Cumberland County Subdivision and Land Development Review Report

Municipality:	<u>Lemoyne</u>	Surveyor/ Engineer:	<u>Alpha Consulting Engineers, Inc.</u>	Owner/ Developer:	<u>Schoolhouse Holdings, LLC</u>
Plat Title:	<u>The Lofts at 701 Market St</u>				
Plat Status:	<u>Preliminary/Final</u>	Plat Type:	<u>Subdivision & Land Development</u>		
# of New Lots:	<u>1</u>	# of New Dwelling Units:	<u>35</u>	New Acreage Subdivided/Developed:	<u>0.54</u>
				Total Tract Acreage:	<u>3.48</u>
Zoning District:	<u>VMU</u>	Proposed Land Use:	<u>Multi Family Residential</u>		
Date Received:	<u>6/29/2020</u>	County Review:	<u>7/8/2020</u>	Reviewed by:	<u>SH</u>
				Checked by:	<u>SW</u>

THE LOFTS AT 701 MARKET STREET

PRELIMINARY/FINAL LAND DEVELOPMENT AND SUBDIVISION PLAN
 SITE/SUBDIVISION PLAN
 FOR
THE LOFTS AT 701 MARKET STREET
 BOROUGH OF LEMOYNE, CUMBERLAND COUNTY, PENNSYLVANIA

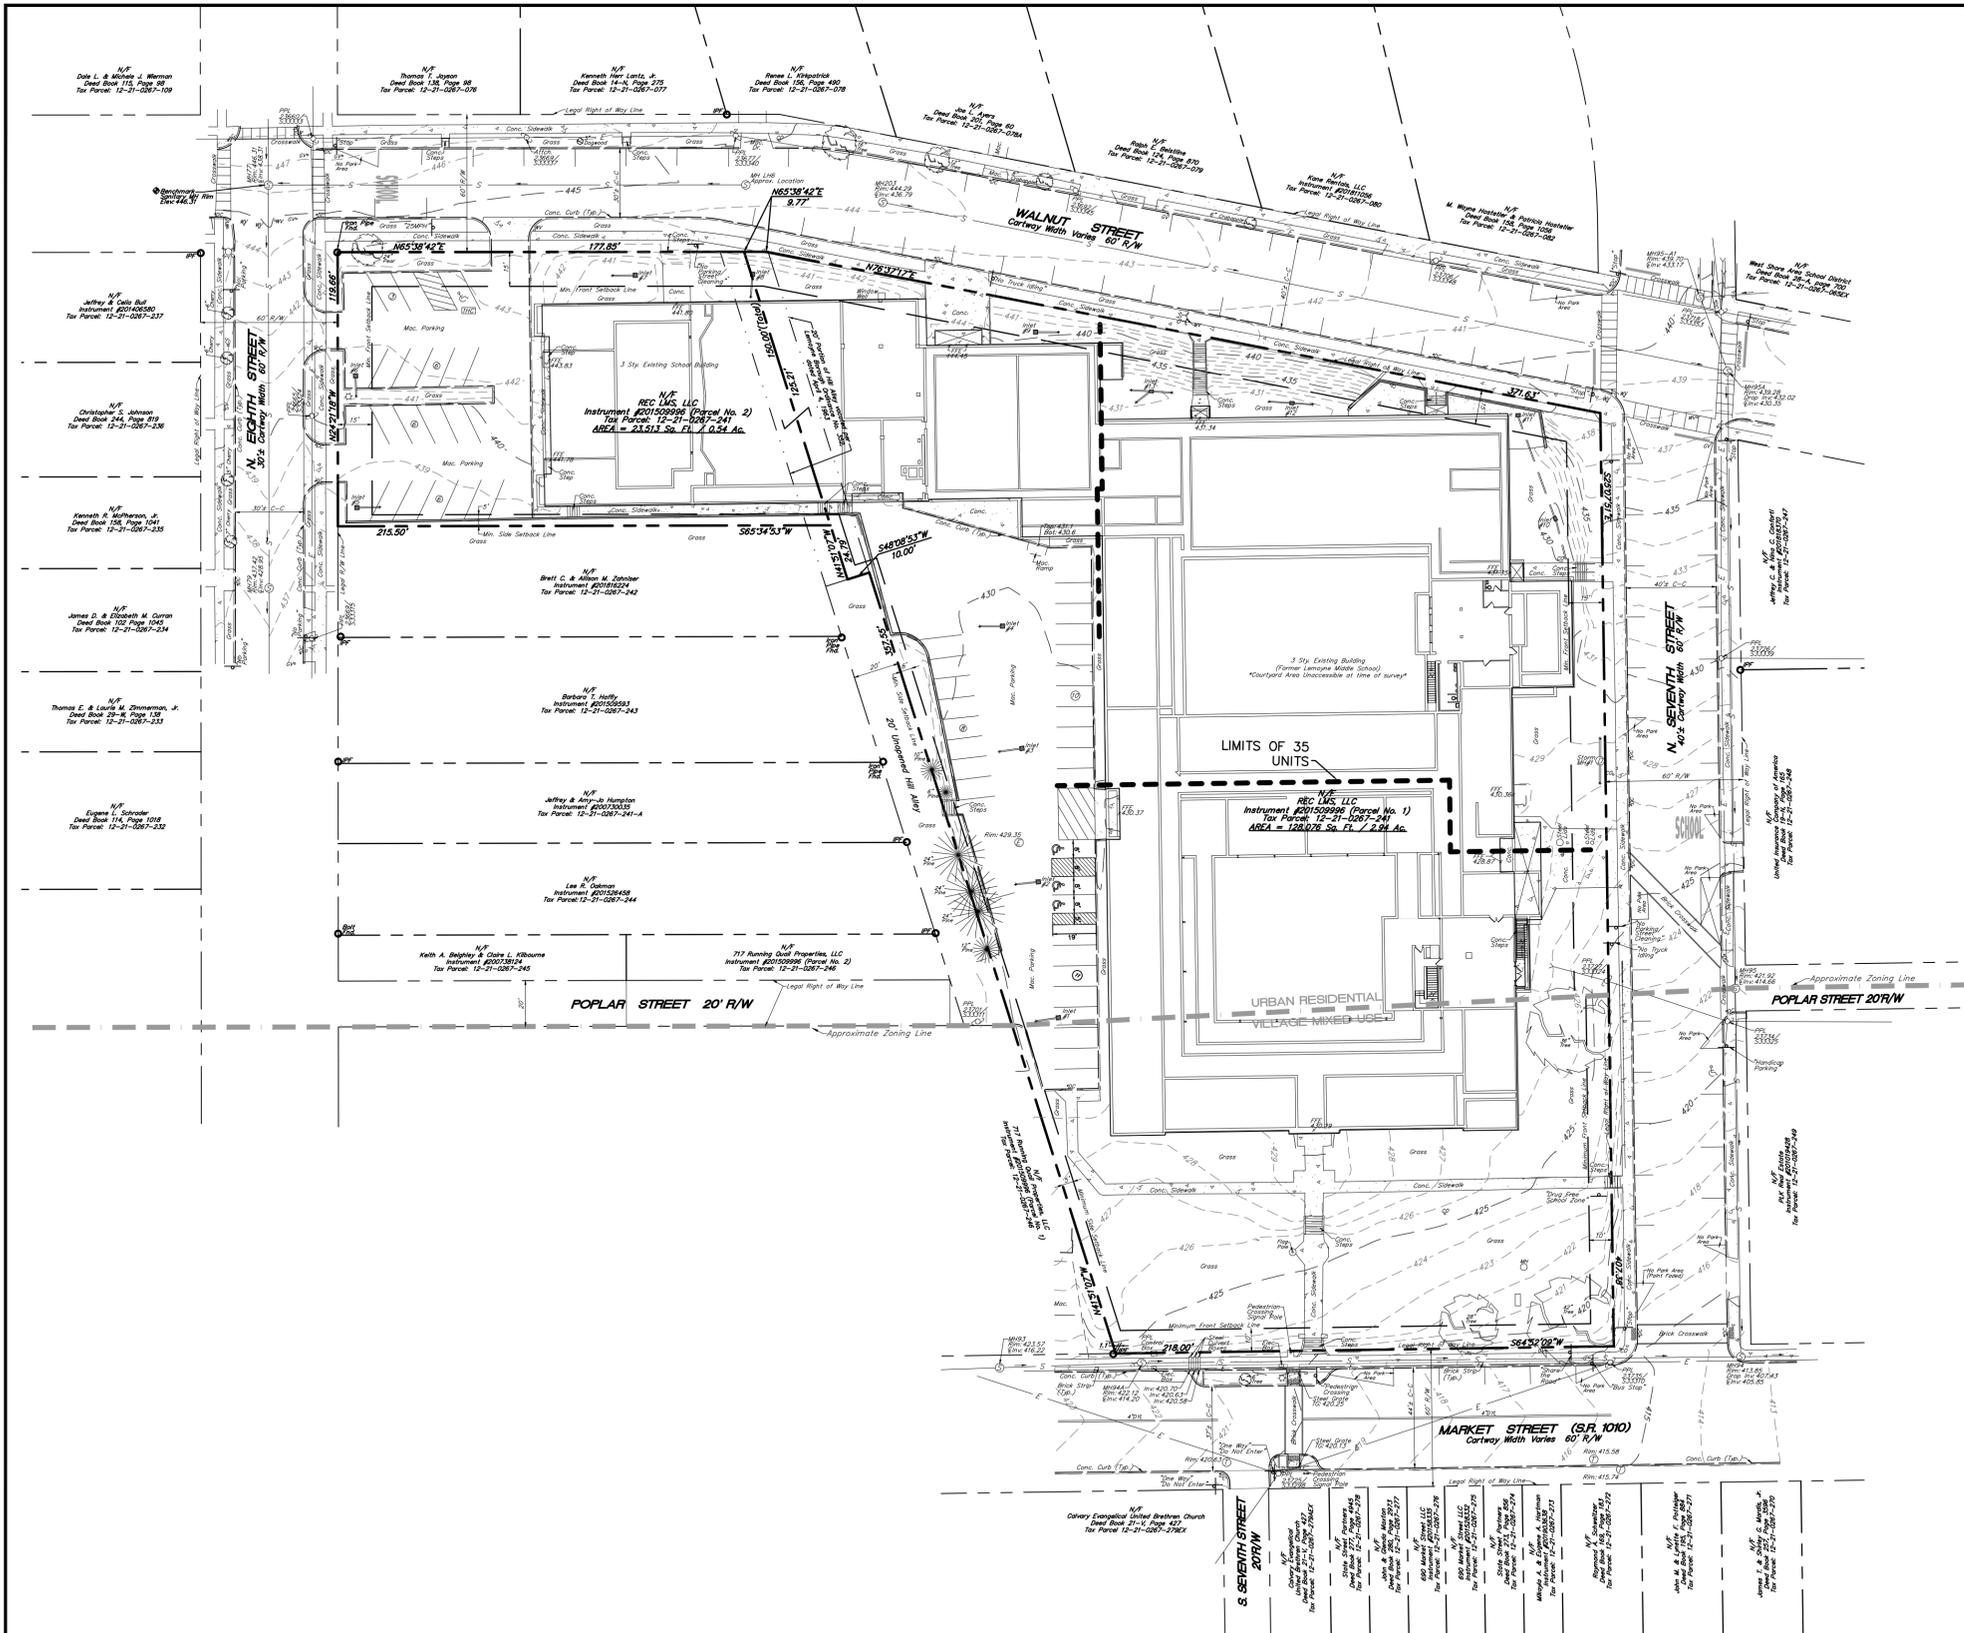
1. The plan should include all of the Zoning Data found in Zoning Ordinance Part 3 and Part 11. In addition, the plan should show the proposed dimensional requirements for proof of compliance, or note an existing nonconformance.

- a. Maximum impervious lot coverage (Zoning Table 3-4).
 - b. Vegetative coverage (Zoning Table 3-4).
 - c. Building height (Zoning Table 3-4).
 - d. Maximum of 8 dwelling units per acre in the UR District (Zoning 1102.B.1.A).

- e. Lot width (Zoning 1102.B.2).
2. The Zoning Data should indicate that the development is located in the Development Compatibility Zoning District (DCO) (Zoning 604).

3. The plan should show the proposed buffer yards and screening between the proposed multi-family use and the existing single family residences along North Eight Street (Zoning Table 7-1).

4. The plan should indicate the location of a dumpster and include the appropriate screening (Zoning 706.H.7).
5. The Applicant and Borough should verify the Parking Data and calculation provided on the Cover Sheet. It appears that the requirement is 2 spaces per dwelling unit plus 0.5 spaces per unit in a common visitor compound (Zoning Table 9-2).

11. The plan should indicate that monuments and/or markers will be placed at property corners (SLDO 406).
12. The plan should include clear sight triangles (SLDO 407.H.5.F).

13. The required and provided sight distances should be included on the plan (SLDO 407.H.5.G).
14. The plan should address the Pennsylvania DEP Sewage Planning requirements (SLDO 416.C).
